Bulletin No.: 15116  
Date: November 2015

# Program Bulletin

**SUBJECT:** Hood Striker Corrosion / Fracture

**MODELS:** 2015-2016 Chevrolet Colorado  
2015-2016 GMC Canyon

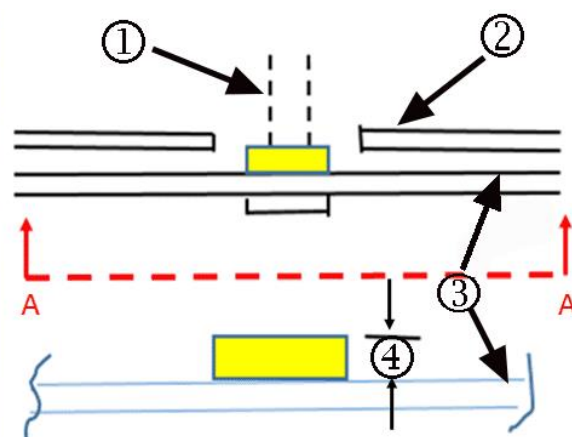
#### Key to Call-outs Noted Above

- (1) Forward screws
- (2) Stationary hood striker
- (3) Rear, inboard hood clinches

1. Open the hood and verify components noted above.

4175312

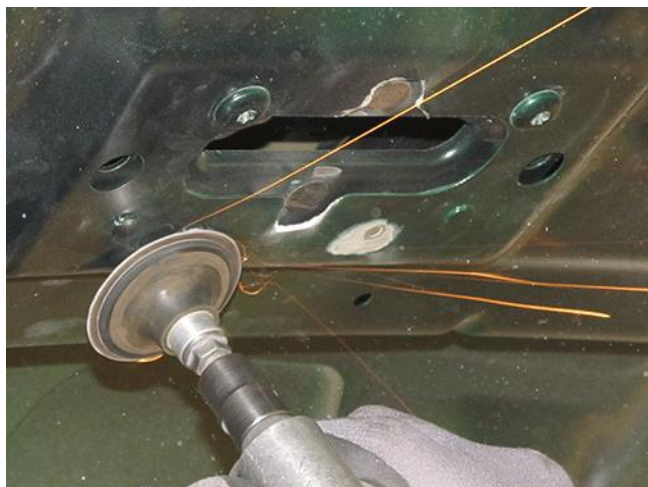
**Important:** When grinding is complete, use a height gage to ensure the remaining striker nub (shown in yellow above) height is no taller than 1.5 mm (0.060 in) (4) above the base metal reinforcement (3).

4. After removal of the striker (1), use a grinding wheel or belt sander to grind down the remaining striker nubs. The nubs should be shorter than the hood inner surface (2) and stand a maximum height of 1.5 mm (0.060 in) above the base metal reinforcement (3).

4170790

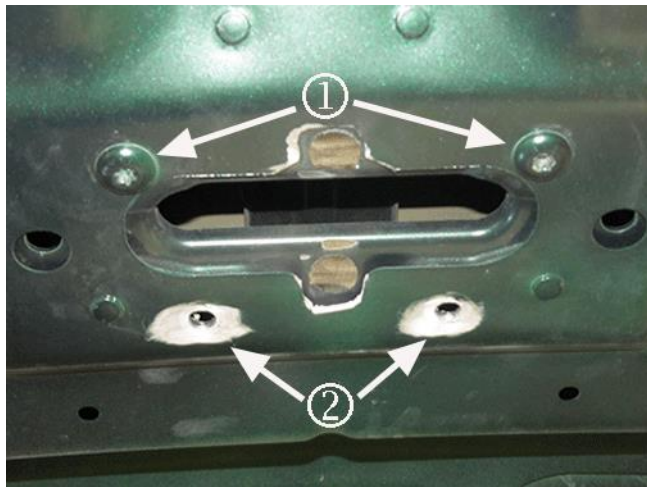
5. As shown in the graphic above, grind flush the two inboard, rear clinches,
